NUMBER
DEP16196

Addendum Number: 1

**Addendum #1 - Questions During Pre-Bid Meeting
Ridenour Complex
DEP16196**

DETAIL - ADDENDUM 1

FIGURE 1

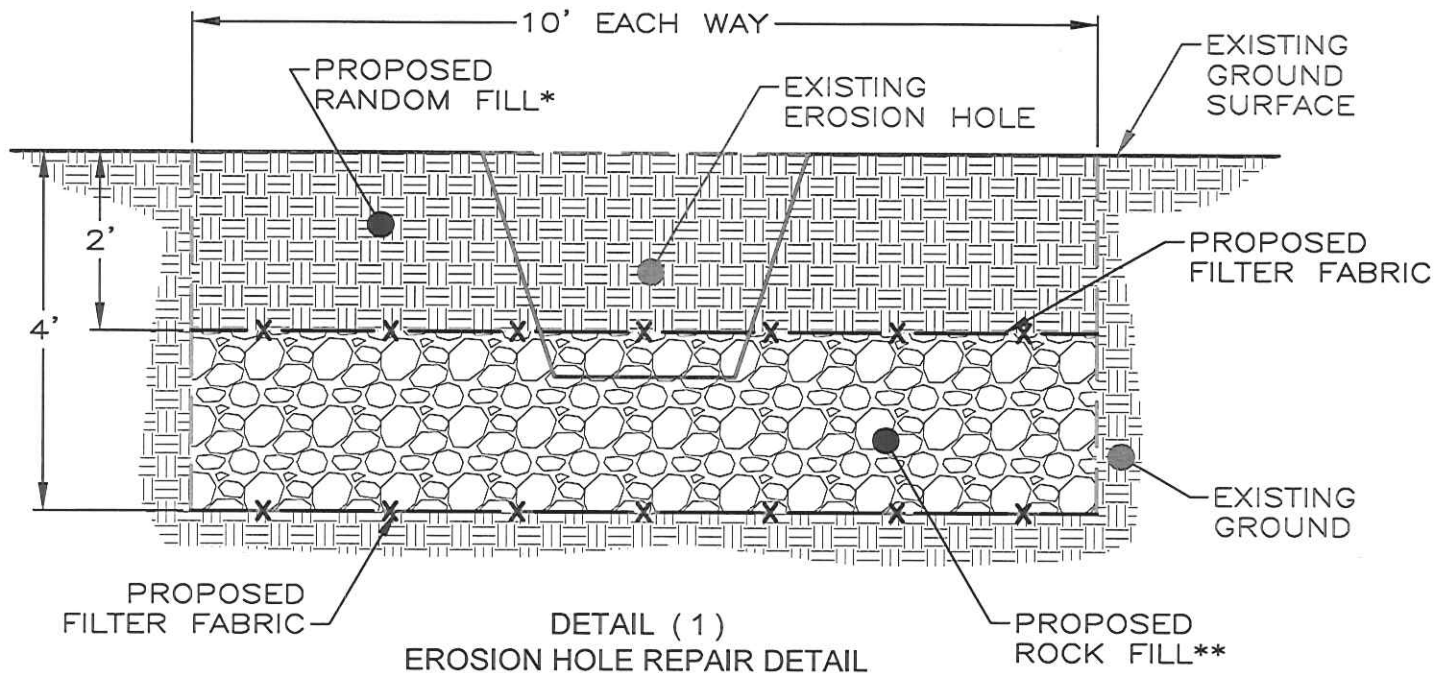
See attached detail for the work associated with the aggregate plug that was described at the pre-bid conference.

* RANDOM FILL TO CONSIST OF BEST ONSITE
COMPACTED CLAYEY FILL AS APPROVED BY
THE WVDEP

** THE ROCK FILL SHALL BE GRADED BETWEEN
PARTICLE SIZES RANGING FROM 2 TO 12 INCHES
AND WITH AN APPROX. D50 SIZE OF 6 INCHES
AS APPROVED BY THE WVDEP.
